DARCY RD PUBLIC SCHOOL

SITE PLAN  
DEMOLITION

Sheet title  
OVERALL SITE  
SECTIONS

Sheet title  
OVERALL SITE ELEVATIONS

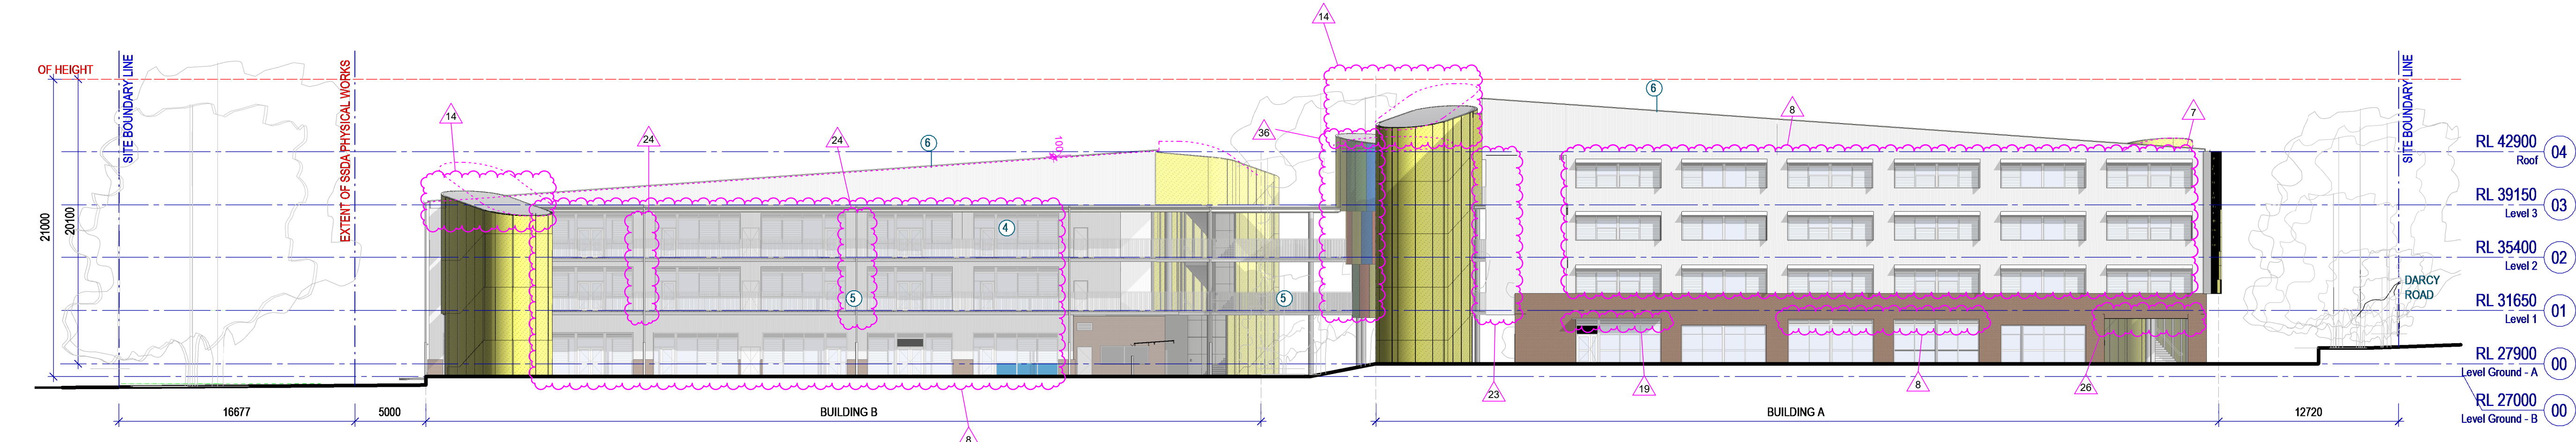
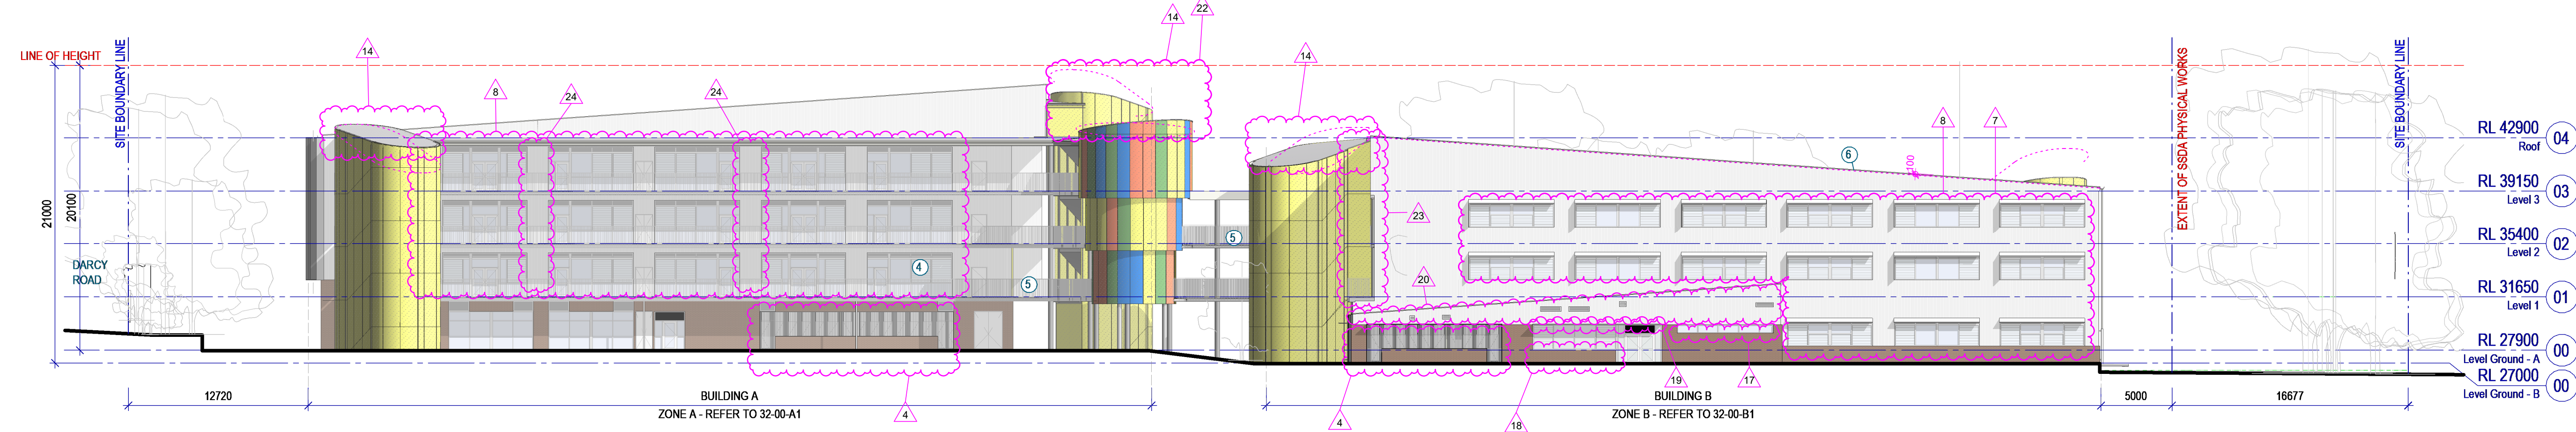
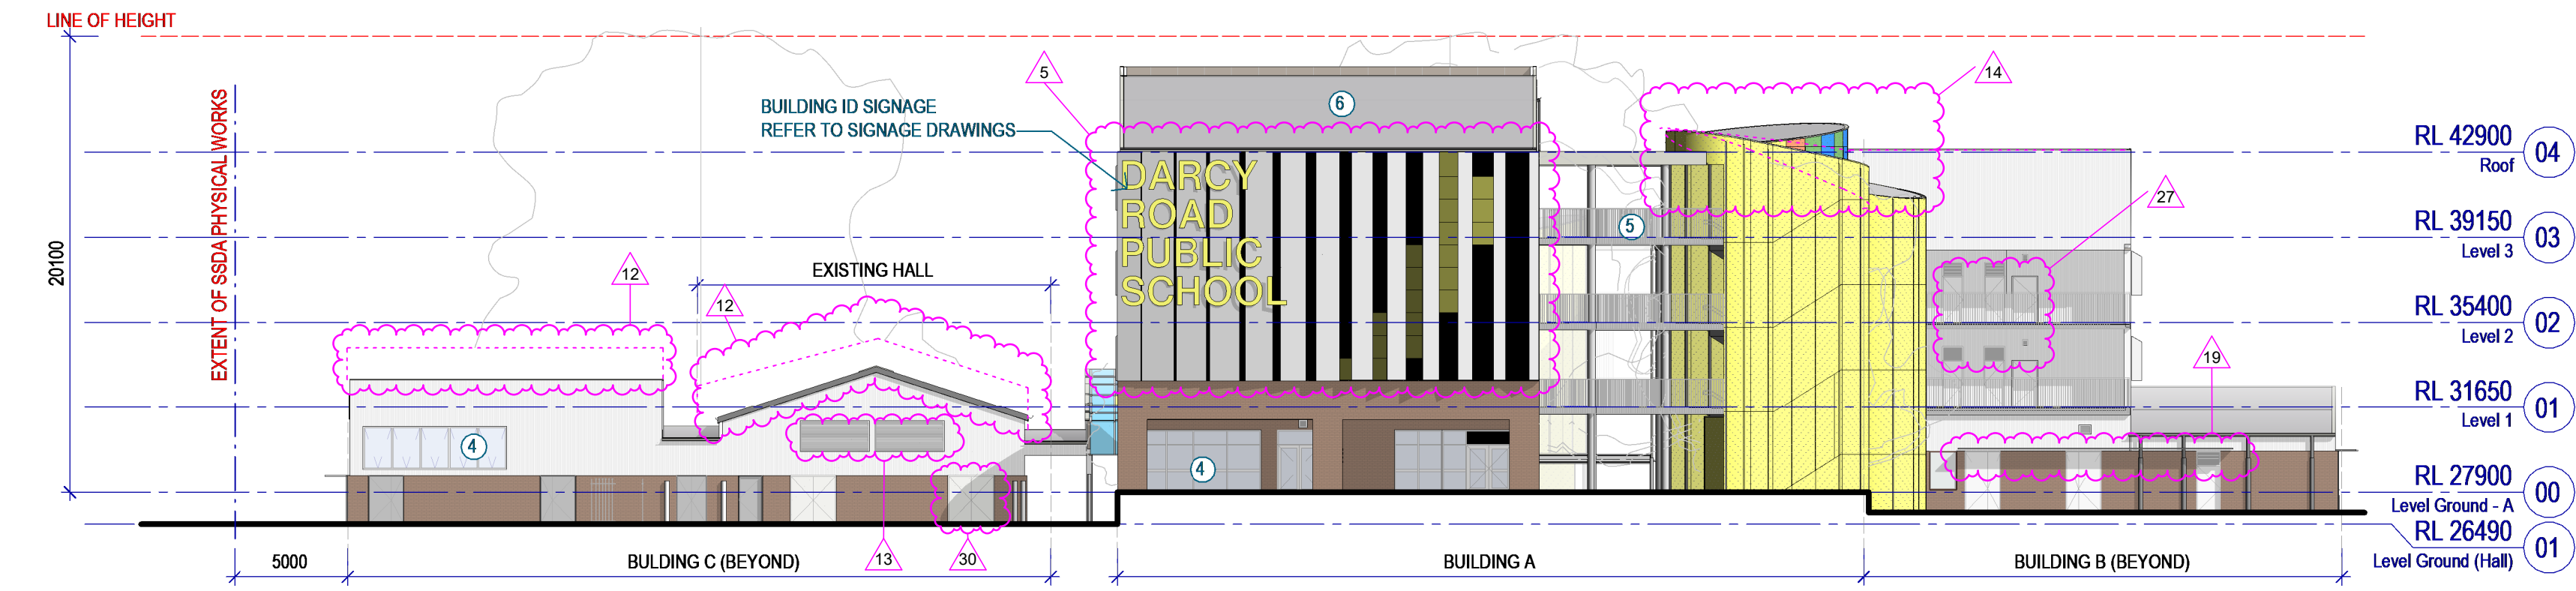
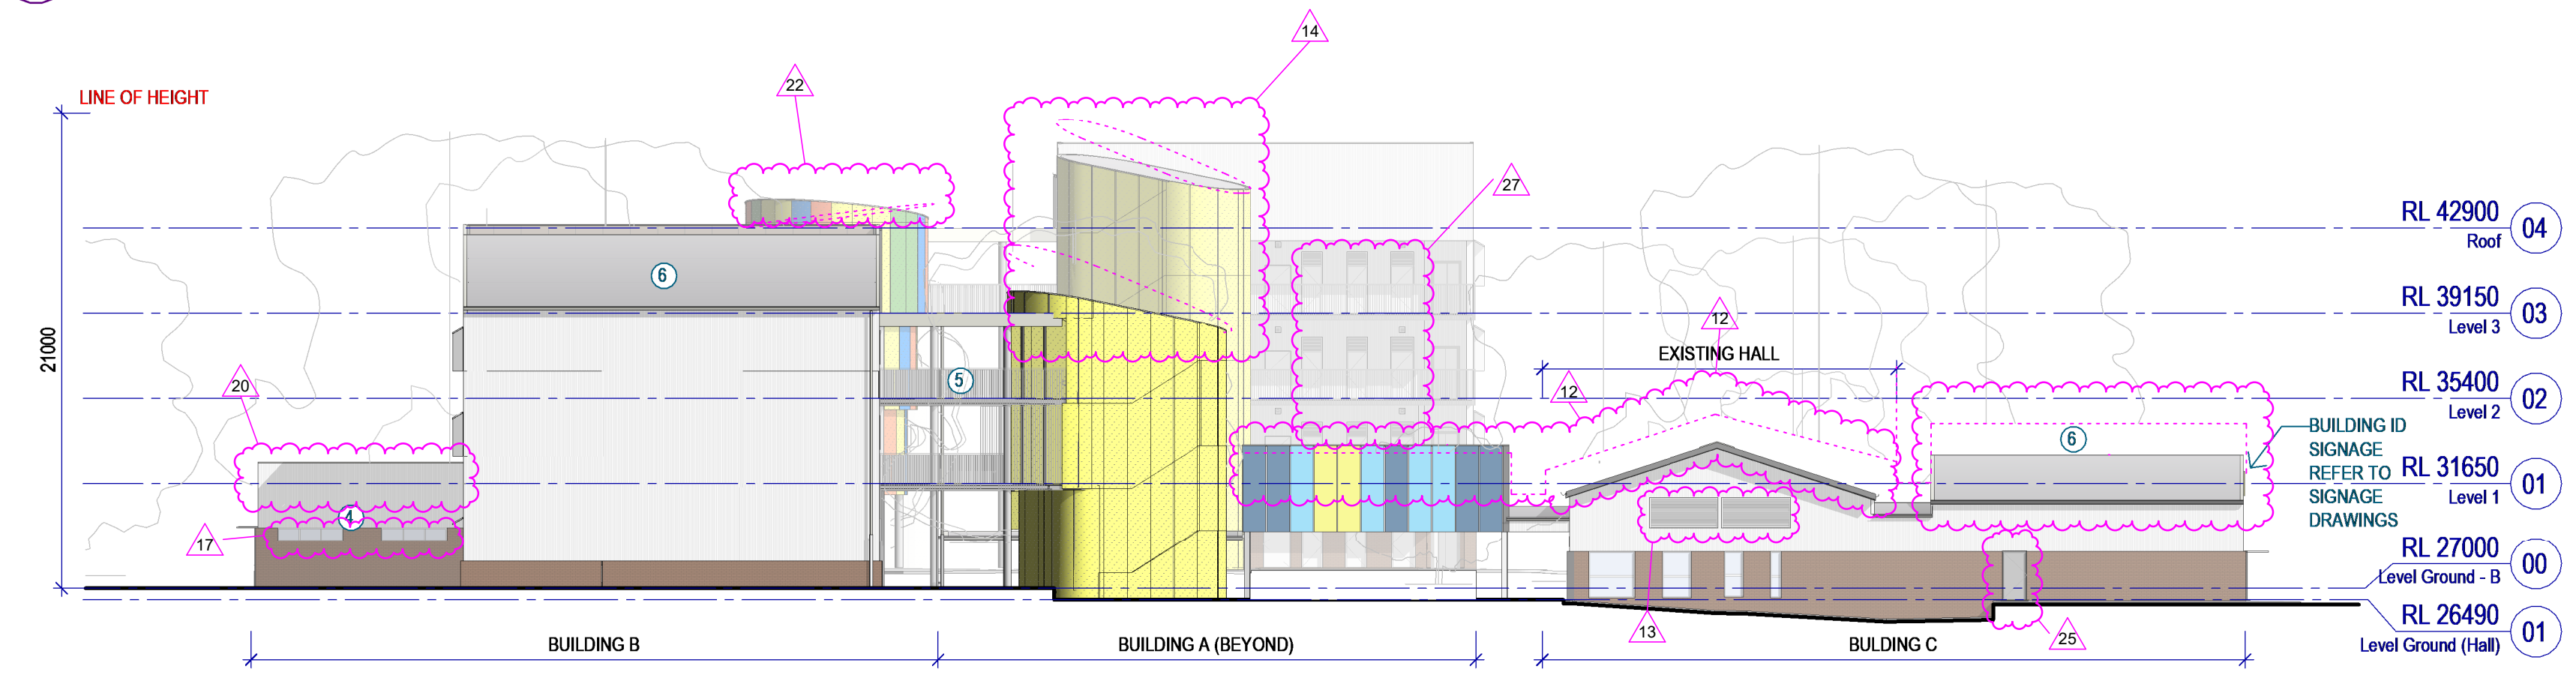
- Below are Architectural amendments from SSDA to DD.  
Refer to SSDA-DD changes report for more details:
- Cladding - Zincalume corrugated cladding changed to Colorbond corrugated cladding colour shale grey, vertical cladding throughout

- Roof - Zincalume corrugated roof sheeting changed to Colorbond Kliplik roof colour Surfmist
  - Brick - Recycled brick plinth changed to Bowral 76 Renovation Gertrudis Brown. Proposed brickwork will be similar to existing brickwork as it has a smoother face and is readily available

- Screening added to ground floor boys and Girls toilets, Brick Lintel removed
  - Northern Building A Facade with large format signage, changed from Corrugated metal sheeting to folded Aluminium powdercoated panels. Replacing the Corrugated Customorb faceted wall with folded aluminium screening would allow the external corrugated wall to be flat and improve weathertightness. There is not enough quantities for the custom Yellow corrugated metal cladding

- Carpark entry amended to accommodate sliding gate location so that staff cars can open the sliding gate via a card reader bollard. Gates to the waste enclosure have also been added.

- External windows amended to allow for a steel mullion to break up window opening size. The Awning windows were replaced with operable louvres
  - Windows size amended to incorporate Mechanical louvres integrated within window frame. Window sill raised to 1200 above FFL.

- COLA polycarbonate panel lengths increased to reduce amount of stepping from 9 to 5 steps
  - Minor amendment to internal Hall and OSHC layout to comply EFSG accomodation schedule.

- Lowering Hall roof to match existing Hall roof height and also lowering the roof over the OSHC by approx. 1.2m
  - Large Ventilation louvres added to north and south gable of Hall

- External stairwell roofs were amended, minor change to roof slope and ridge lowered
  - Staff EOT's amended to include a Airlock and sepearate Male and Female WC/EOT

- Airlock added between Canteen Back of House office and Ambulant WC
  - Special Programs windows lowered below 3m of the internal ceiling level
  - Low height Brick wall increased to 950mm above FFL to GF western elevation of Library

- Sunhoods added on ground floor over door ways required by façade consultant to prevent water ingress through doors
  - Horizontal corrugated zincalume cladding changed to vertical corrugated colorbond cladding

- Stair 03 slightly shifted to the north-west to avoid bottom landing encroaching into main circulation spine.
  - Roof pitch to interconnecting node amended to fall onto walkway roof, ridge is slightly higher

- Vertical metal cladding in lieu of balustrade to protect Lift shaft + Comms
  - EDB door removed to upper level walkway, This consolidates the EDB to be located between typical Leaning hubs.

- Door shifted to align with revised internal layout
  - Soffit level raised to match northern soffit of GF Block A
  - Ventilation louvres added above doors

- External round Concrete Columns removed for the stairs and Concrete column moved
  - Northern western door to Hall moved away from downpipes
  - Lift Alcove added due to reduced size of Lift well depth.

- FHR in corner store room location amended
  - Roof ridge mounted ventilation fans to Hall
  - New low height roof over MSSB
  - Extent of solar panels amended

- Extra colours added to Central building link
  - Stair 04 ground floor landing amended to be 6m away from the building
  - Concrete floodwall (For targeted flood protection) to south western corner of Block B
